REMARKS

VERSION WITH MARKINGS TO SHOW CHANGES MADE

FIGURE 4

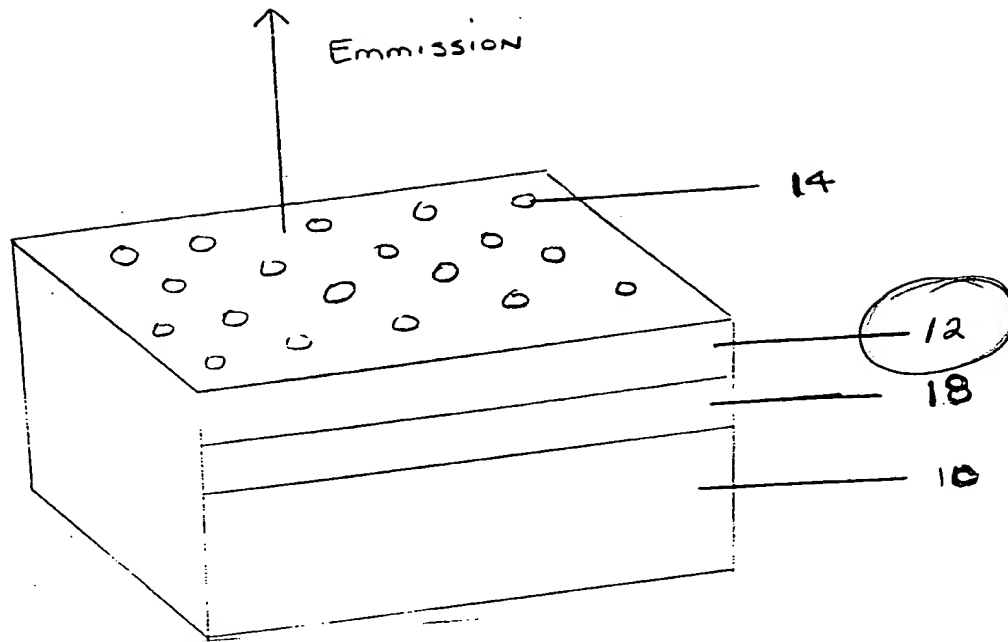
In paragraph 3 of the Office Action the Examiner objected to the drawings under 37 C.F.R. § 1.83(a) for failing to show “the LED, the wavelength converter, the sensor or the switch” and stated that these items were essential for a proper understanding of the disclosed invention according to MPEP §608.02(d). In addition, the Examiner objected under 37 C.F.R. § 1.84(p)(5) because reference character 22 in Figure 4 is not mentioned in the specification. Reconsideration is requested.

Applicant is grateful to the Examiner for pointing out the error contained in Figure 4. Reference character 22 should read 12. Antecedent basis for this correction can be found in the specification page 13, lines 9-19, which gives a description of the layers in the present invention. A drawing correction is attached hereto with corrections in red ink.
